TO: Mercedes-Benz Dealer Principals, General Managers, Sales Managers, Service Managers, Parts Managers	FROM: Gregory Gunther, Department Manager, Vehicle Compliance and Analysis, Engineering Services
RE: Recall Campaign Launch Notification Check the Adjustment Range Limitation of the Passenger Seat MY19-21 213 (E-Class)	DATE: December 11, 2020

Recall Campaign Launch Notification			December 11, 2020
Campaign No. :	NHTSA ID	Campaign Desc. :	Check the Passenger Seat Adjustment Range Limitation
2020110013	20V673	20P9190206	
<p>This is to notify you of the Recall Campaign Launch to check the adjustment range limitation of the passenger seat in 1,337 Model Year (“MY”) 2019-2021 E-Class (213 platform) vehicles. The recall campaign will be visible on the www.safercar.gov website and may generate questions from customers. Affected VINs will be flagged in VMI as “OPEN” on December 11, 2020.</p>			
Background			
Issue	Mercedes-Benz AG (“MBAG”), the manufacturer of Mercedes-Benz vehicles, has determined that on certain Model Year (“MY”) 2019- 2021 E-Class vehicles (213 platform), the mechanical seat adjustment range limitation for the front passenger seat might not have been installed. In th

Figure 1

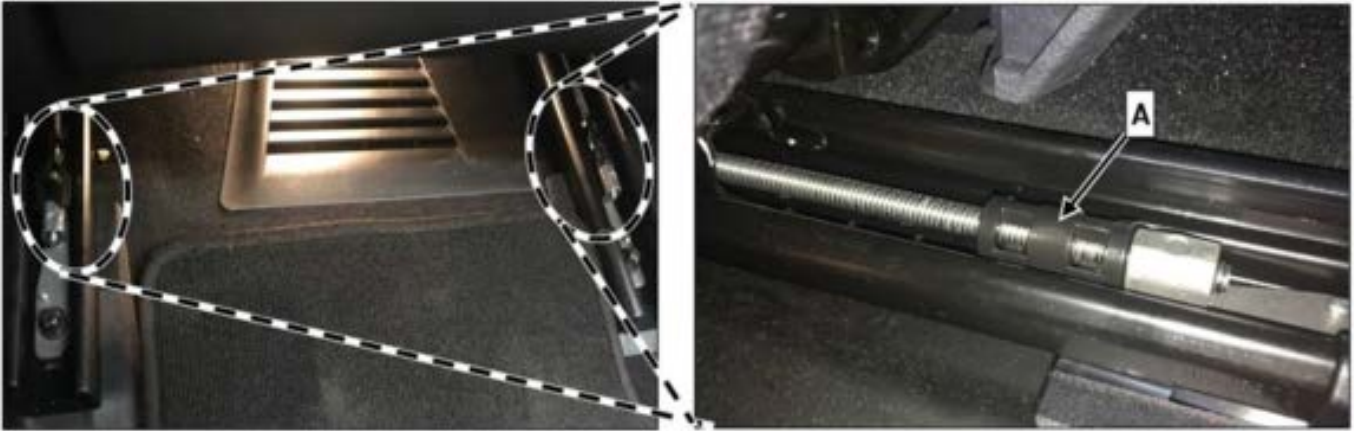
i Check that seat travel limiter is present at front and rear of seat frame base of front passenger seat.

1. Move front passenger seat to front-most/rear-most position.
2. Check for presence of seat travel limiter (**A, figure 1**).
 - a. Seat travel limiter present: **End measure**.
 - b. Seat travel limiter **not** present: Perform **work procedure**.

Figure 2

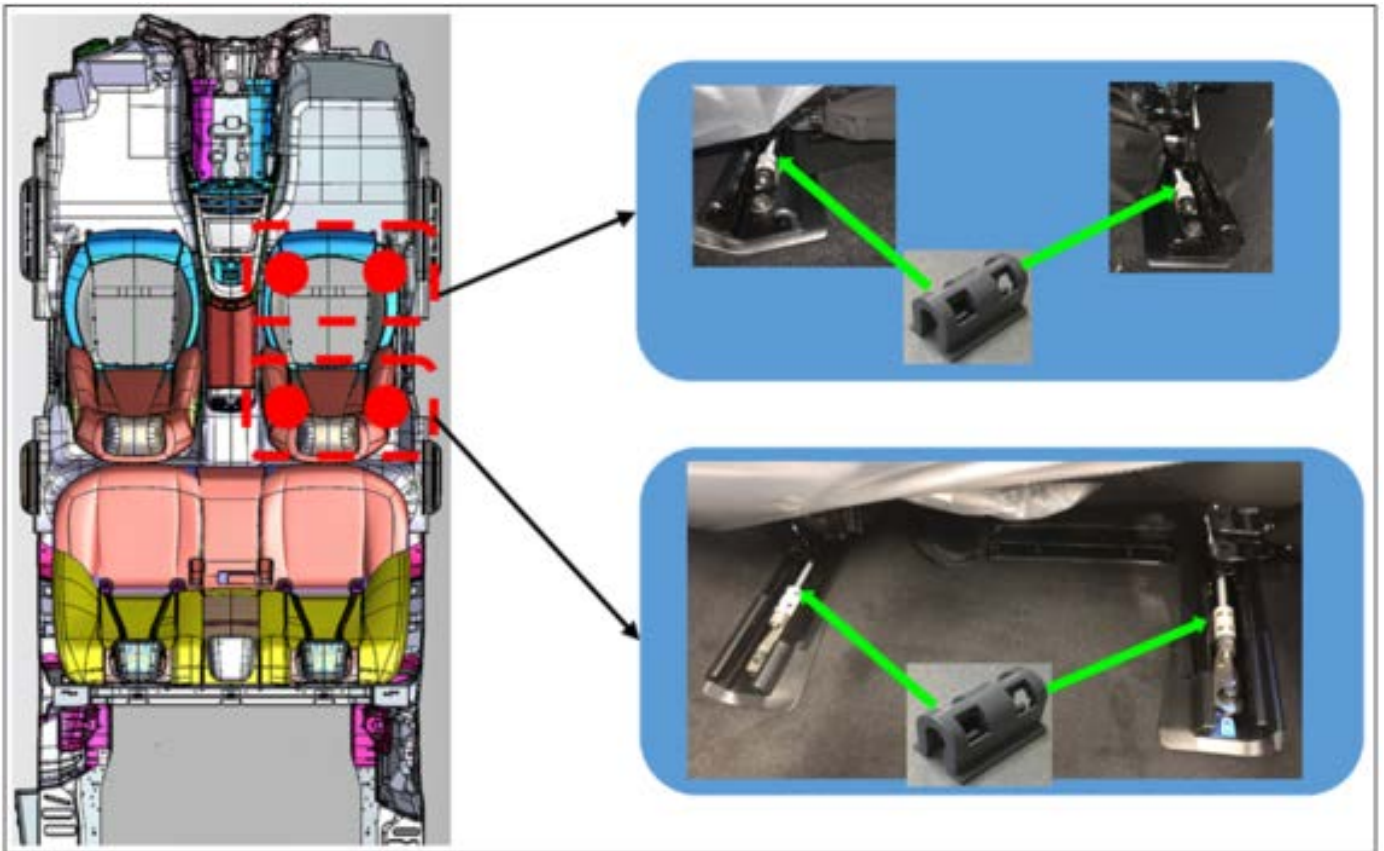
1. Retrofit seat travel limiter (**figure 2**) at **rear** seat frame base of front passenger seat.
 - 1.1. Move front passenger seat to front-most position.
 - 1.2. Install seat travel limiter at left and right rear spindle.
 - i** To install, press travel limiter onto the spindle in the location shown in (**Figure 2**)
 - 1.3. Position seat travel limiter at rear limit stop of spindle.
2. Retrofit seat travel limiter (**figure 2**) at **front** seat frame base of front passenger seat.
 - 2.1. Move front passenger seat to rearmost position.
 - 2.2. Install seat travel limiter at left and right front spindle.
 - i** To install, press travel limiter onto the spindle in the location shown in (**Figure 2**)
 - 2.3. Position seat travel limiter at front limit stop of spindle.
